Review of Environmental Factors

Addendum

Sewerage System Upgrade Mort Street, Balmain

Figure 2 Project Change - Ecology

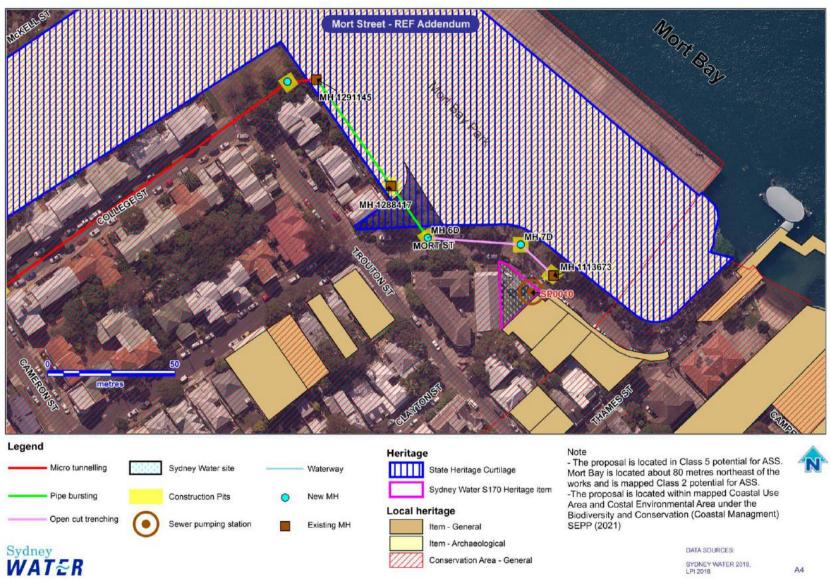
- construction of two new MH (MH6D and MH 7D), in a different location to the initial proposal, on Mort Street with a construction footprint of about four metres by four metres
- pipe bursting of about 25 m from MH 1288417 to MH 6D, requiring a four metre by four metre pit at MH 1288417
- replacement of existing 150 VC pipe with new DN225 pipe
- installation of approximately 50 m of new DN225 between MH
 6D and MH 1113673 via MH 7D, using open cut trenching.

These changes are in place of the original proposal to establish a pit, construct a new MH and install 90 m of DN 225 pipe via micro tunnelling in Mort Bay Park. No additional households will need to be temporarily disconnected from the wastewater system as there are no further connections from MH 1288417 to MH 6D.

The proposed excavation subject to this REF Addendum will take place in the road alignment of Mort Street. There are several curbside trees adjacent to Mort Street. It is not anticipated that the excavations will impact these trees as the works are located outside of their TPZ. There are no trees to be removed as part of the project change
